Access Compliance Report

Public Rights-of-Way (Curb Ramps)

Intersection ID: 10019011	Main Street: BRANDIE_GLEN_RD	Cross Street: N/A	Location:	N
ADA ID: A728EC5D89AE	Ramp Type: Directional1	Initial Pass/Fail: Fail	Overall Compliance: No	Severity Score: 10

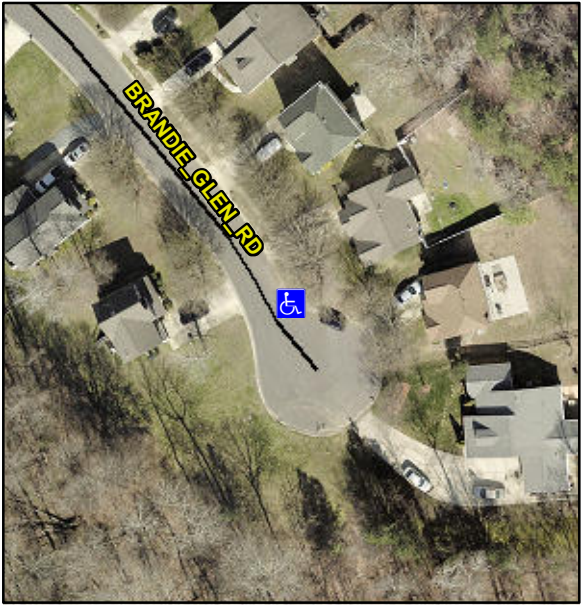
Codes/Mitigation Info/Possible Solution			Field Measurements/Component Compliance			
	Possible Solutions:		Compliance	Description	Data	
	Remove & Replace Entire Ramp.		N/A	Ramp Length (in)	66.0	
			No	Ramp Width (in)	47.0	
			Yes	Ramp Slope (%)	6.0	
			No	Ramp XSlope (%)	3.0	
			N/A	Flare Type LT	N/A	
			N/A	Flare Slope LT (%)	N/A	
			N/A	Flare Traversable LT?	N/A	
			N/A	Landing Length (in)	0.0	
			N/A	Landing Width (in)	0.0	
Surveyor Notes: N/A			N/A	Landing Slope (%)	0.0	
			N/A	Landing X Slope (%)	0.0	
			N/A	Landing Curb? (Y/N)	N/A	
			N/A	Shared Landing?	N/A	
			N/A	Gutter Ponding?	0.0	
			N/A	Gutter Lip Ht (in)	0.5	
			N/A	Painted X Walk1?	No	
				X Walk 1 Direction	To W	
				X Walk 1 Width (in)	N/A	
				X Walk 1 Slope (%)	2.8	
PROW/ADA: R304.5.1, R304.5.3				X Walk 1 X Slope (%)	1.3	
			N/A	Ramp inside XWalk1?	N/A	
			N/A	Any Obstructions?	N/A	
				Obstruction Type		
			Yes	Surface Condition? (G/P)	Good	
			N/A	Curb Slope (%)	N/A
